AMENDMENT UNDER 37 C.F.R. § 1.111
U.S. Appln. No. 10/699,865

AMENDMENTS TO THE DRAWINGS

FIG. 7 PRIOR ART

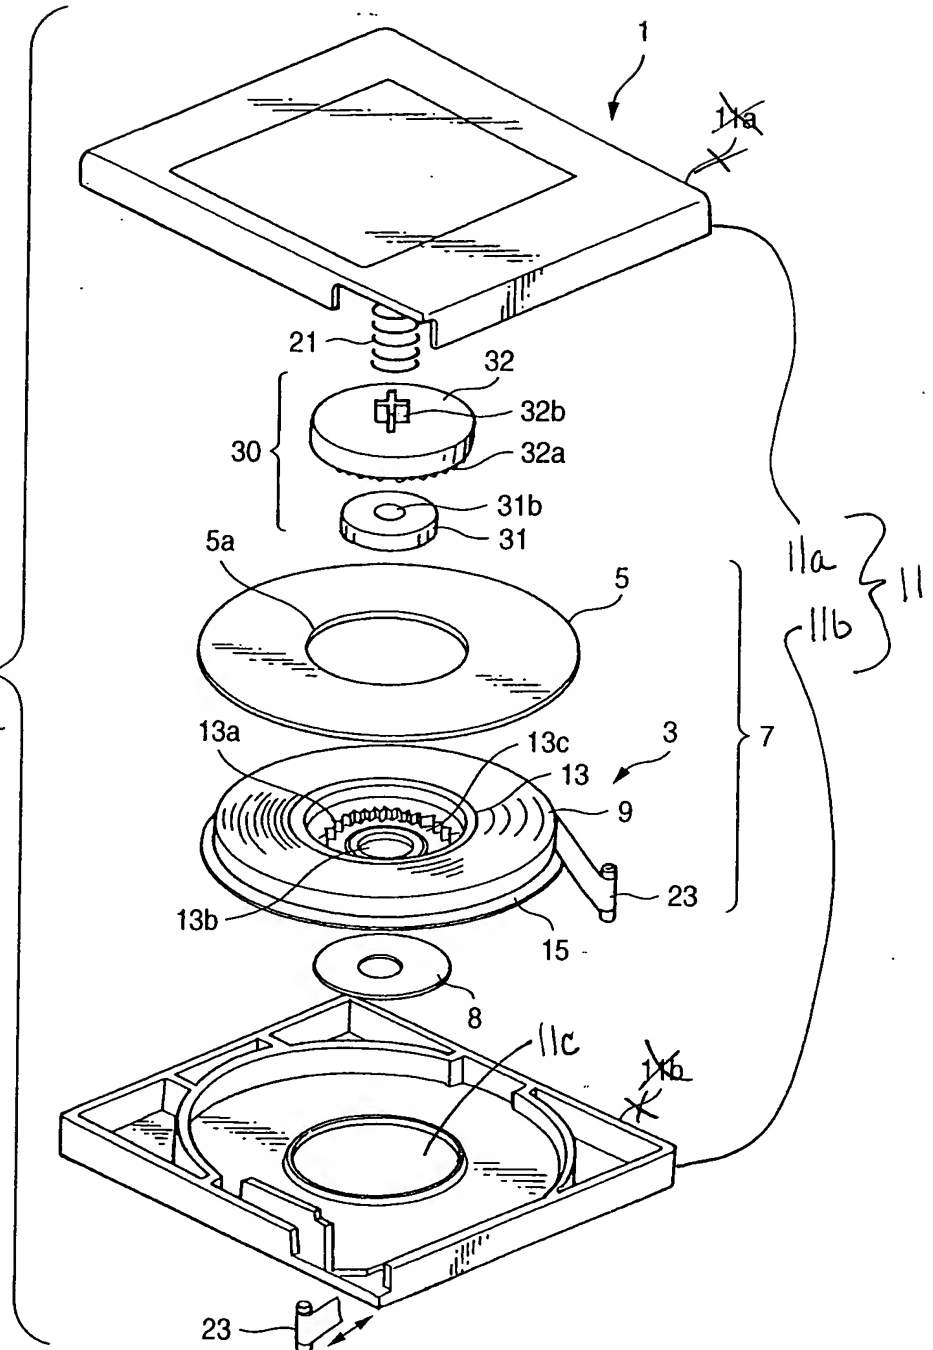
The Examiner has objected to FIGS. 6-8b because they are not labeled --Prior Art--. Applicant amends the drawings to overcome this objection.

The specification is objected to because it appears that “31” is used for two different elements, the first member and the plurality of grooves. Applicant amends the specification and Fig. 7 to refer to the plurality of grooves as “15a”. Also “aperture” on page 9, line 24 is misspelled. Also, FIGS. 8a and 8b are now described separately in the Brief Description of the Drawings.

The Examiner considers the grooves of the prior art flange in Fig. 7 to render the flange “porous”. Applicant respectfully disagrees with this assertion. In particular, porous is understood by those of ordinary skill in the art to mean “having or full of pores” and pores are understood by those of ordinary skill in the art to be “tiny openings”. See *The American Heritage Desk Dictionary*, Houghton Mifflin Company, 1981. Common synonyms for porous include “absorbent” and “permeable”.

The prior art flange of Fig. 7 is not porous; rather this flange has very large portions missing altogether, so that the center of the flange is connected to the perimeter of the flange by spindle-like portions. This is completely different than a porous surface.

Applicant has amended FIGS. 6, 7, 8a and 8b to include the legend --Prior Art--. Also, FIG. 6 has been amended to add reference numerals “11” and “11c”. Finally, reference numeral “31” in FIG. 7 has been amended to --15a-- in both instances. The submitted annotated marked-up drawings and replacement sheets are believed to obviate the Examiner’s objection to the drawings.
